REMARKS

VERSION WITH MARKINGS TO SHOW CHANGES MADE

IN THE SPECIFICATION

Fig-1

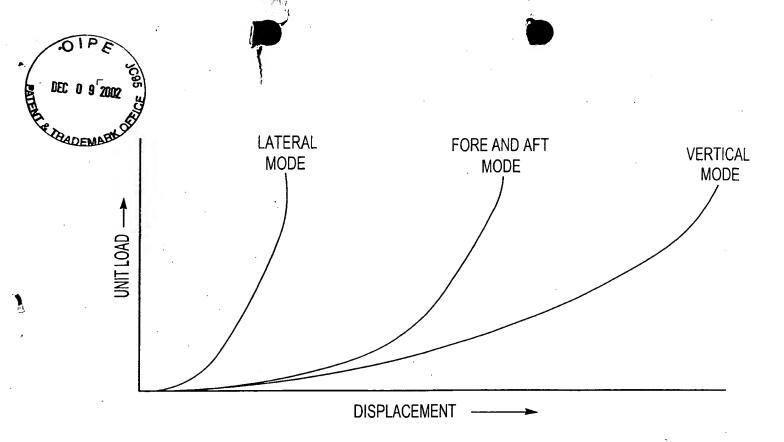
As used herein, fore and aft mode shake means front to back movement or displacement which is along the longitudinal axis of the vehicle and transverse of the axis of a mount and is identified by the [letters F & A in Figure 3] letter F in Figure 2. Vertical mode shake means up and down movement or displacement which is along the axial axis of a mount and identified by the letter V in [Figures 4 and 6] Figure 2. Lateral mode shake mans side to side movement or displacement that is transverse of the longitudinal axis of the vehicle and is perpendicular to the fore and aft mode shake and identified by the letter L in [Figure 6] Figure 2. Lateral shake stiffness is the displacement of a mount in the lateral mode shake direction divided by unit load. Vertical mode shake stiffness is the displacement of a mount in the vertical mode shake direction divided by unit load. Fore and aft shake stiffness is the displacement of a mount in the fore and aft mode shake direction divided by unit load. The desired lateral mode, fore and aft mode and vertical mode load versus displacement relationship for a vehicle is shown in Figure 1.
